Potentially affected equipment :

ATOM MILLENIUM type :

Observations :

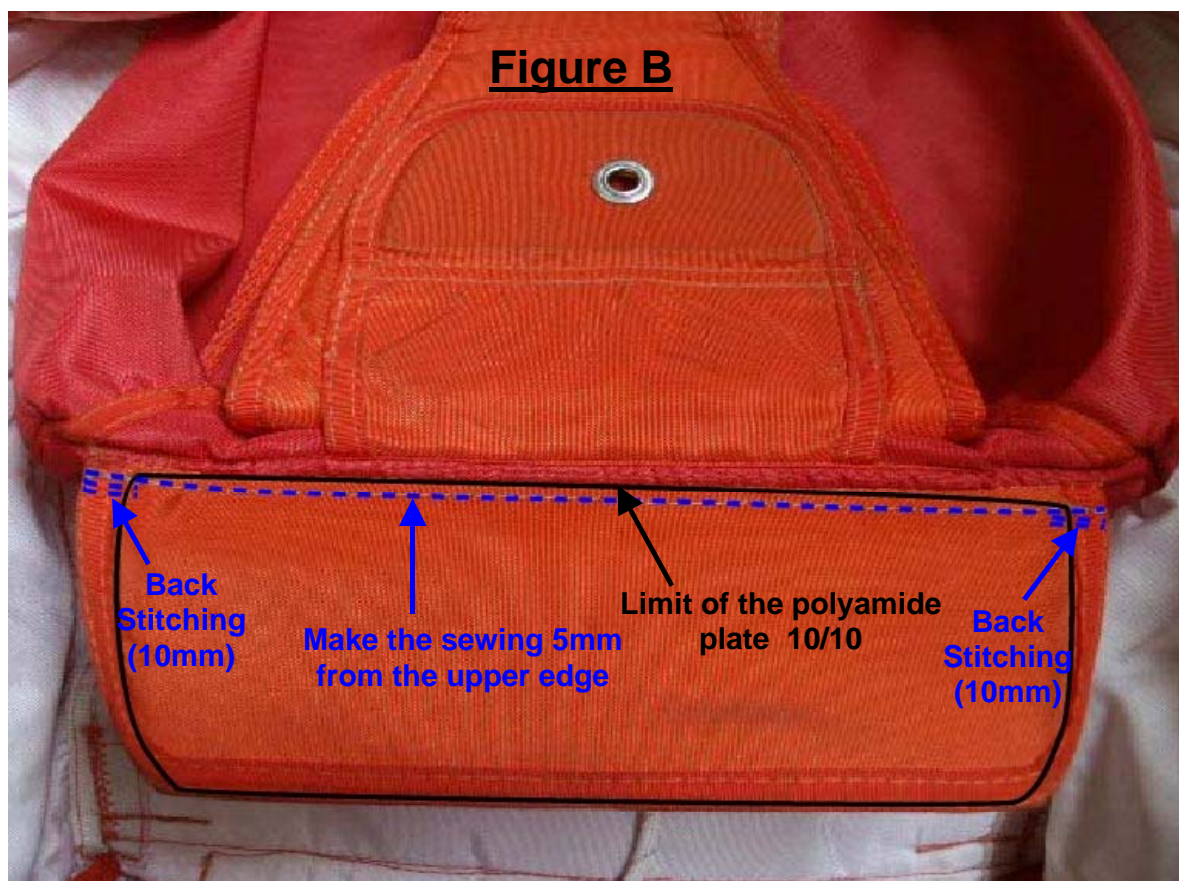
A deformation of the polyamide plate 10/10 (internal plate) of the deflector flap may occur near the sewing that binds the deflector flap to the container (see figure A).

Depending on the way the deflector flap is placed on the main deployment bag during the packing process, it may be deformed in time and its efficiency may be reduced.

Case N°1 : In the event of a deformation as shown on figure A : Before using the equipment again, get a qualified rigger to make a sewing on the deflector flap as shown on figure B.

Case N°2 : In the event of an absence of deformation : As a precaution, also get a qualified rigger to make a sewing on the deflector flap as shown on figure B during the next repacking of the reserve canopy at the latest.

Make a sewing all along the deflector flap (normal stitch) making sure that the polyamide plate 10/10 (internal plate) is included in the sewing. (The reserve canopy needs to be removed from the reserve container).

- Use polyamide thread 66 strength up to 6 kg (ref PF 9002402000 : Thread for container (30/3) or any equivalent),
- make 5 to 6 stitches every 2 cm,
- make it 5 mm from the edge,
- make two 10mm back stitching at the both ends of the sewing.
